October 11, 1946

Number 87

SUBJECT: PLEXIGLAS WINDSHIELD

TO: OWNERS OF J5A AIRPLANES

FIGURE I

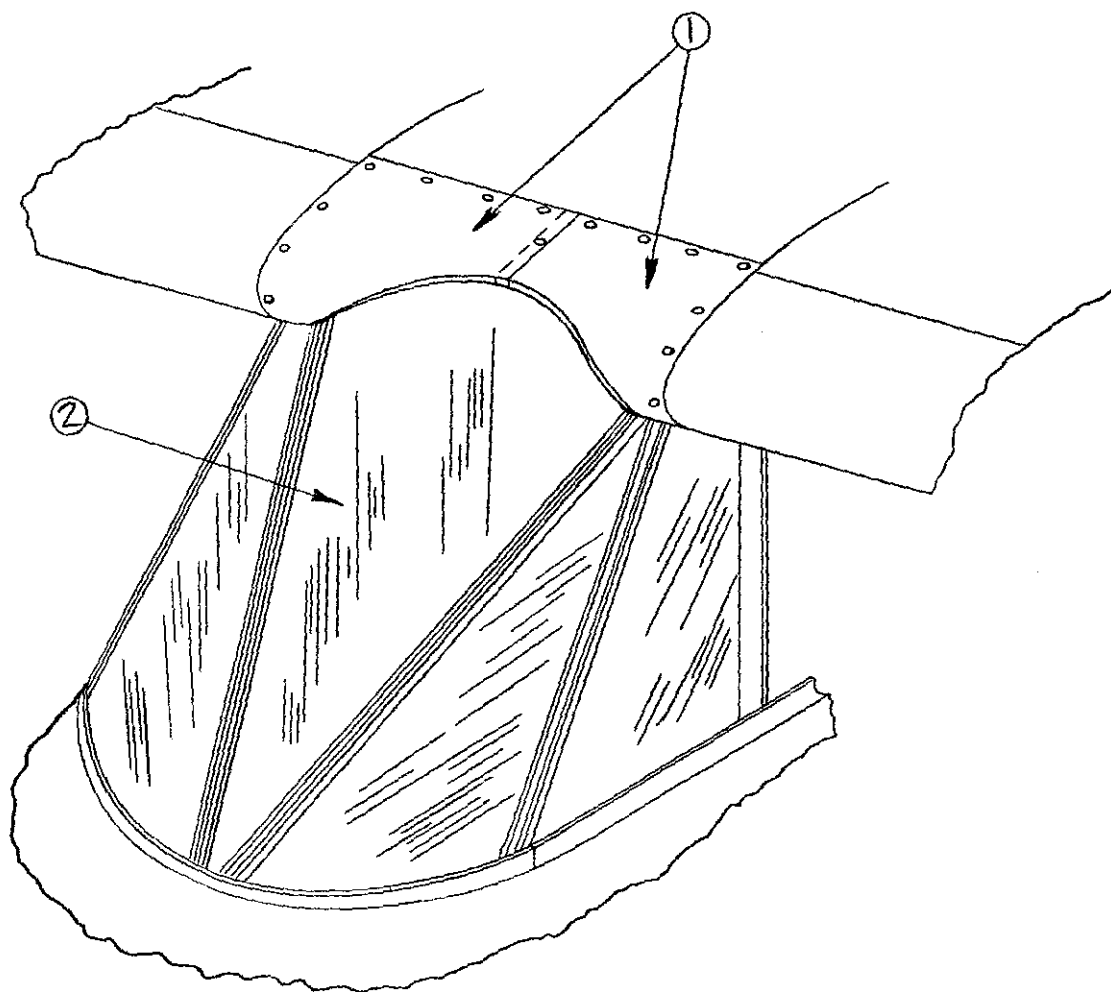
1. Remove the eyebrow fairings (1, Fig. I) and windshield (2, Fig. I).
2. The three 6" pieces of rubber beading (Part No. 81511-11) will be slipped over the lower edge of the windshield and cemented in place, one on either side of the windshield, adjacent to the windshield strip (Part No. 50241-5) and the third 6" piece will be at the front center of the windshield. These strips of beading will prevent the lower edge of the windshield from chafing through the fuselage cowl. (See Section A-A, Fig. II).

FIGURE II

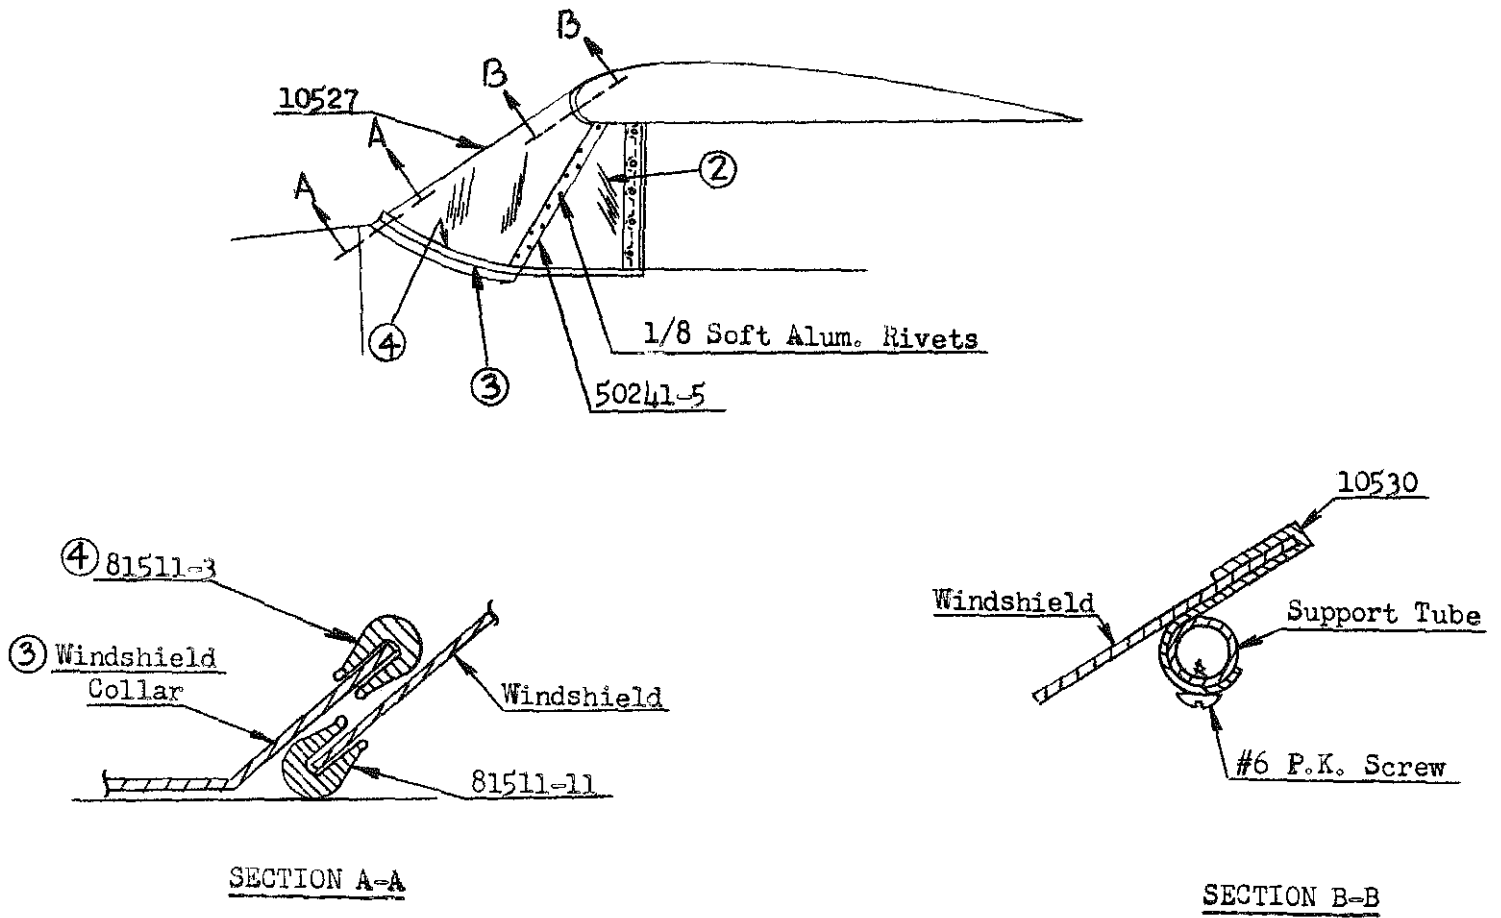
3. The triangular window (2, Fig. II) on the right and left sides are to be replaced by the owner, (using a minimum of .060 pyralin or vinylite). They are attached to the windshield assembly (Part No. 10527) by 1/8 soft aluminum rivets, using 10 on each side. (See Fig. II).

4. The windshield can now be installed by slipping the bottom edge under the windshield collar already attached to the fuselage cowl. (3, Fig. II), and attached at the top by means of the two steel clips (Part No. 10530) included in the assembly. The clips will be slipped over the top edge of the windshield, formed around the windshield support tube and attached by means of #6 P. K. screws driven up through the clip and into the support tube at a point near the wire support attached to the fuselage sabane member on the right and left sides. (See Section B-B, Fig. II). The rubber beading (Part No. 81511-3) can now be placed around the windshield collar (4, Fig. II).

5. The triangular window (2, Fig. II) having been attached to assembly No. 10527, may now be drawn back on right and left sides and attached as it was originally on the back and bottom edges.
